Ducted Systems Technical Services: Service Tips Letter

Letter: ST-002-23

- To: S1 HVAC Branch and Distributor Principal, Sales Manager, Service Manager, Parts Manager, Warranty Manager, Ducted Systems Technical Services, DS (Ducted Systems) Parts/S1, Sales, Warranty teams
- Subject: Product Safety Notice S1- STEAM8000T01 Steam Humidifier Electrode Wire Replacement
- Product/s: Johnson Controls, Inc. Steam Humidifier, S1- STEAM8000T01

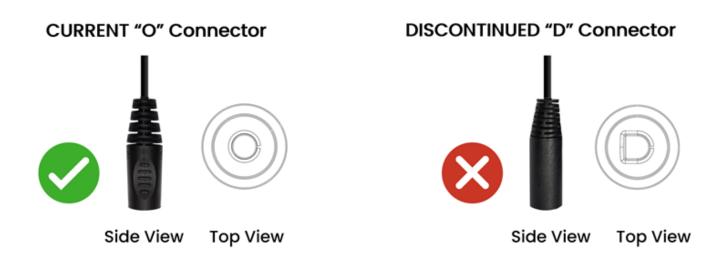
Replace the electrode wires if the connections are loose, damaged, or have been in service for 3 or more years (S1-5274). If the electrode wires of these units are not replaced as recommended, they could potentially cause a safety notice.

In steam humidifiers produced from 2010-2015, the electrode wires used a <u>D-shaped connector</u> that could become loose over time, causing poor electrical conductivity within the canister. This could, in turn, potentially lead to a thermal event rendering the unit inoperable.

Contractors can earn a US\$200 incentive for every pair of "D" shape electrode wires they replace with "O" shape connectors. Online incentive program submission must be received on or before June 30, 2023. Click <u>here</u> to submit your incentive submission and to review full incentive program terms and conditions.
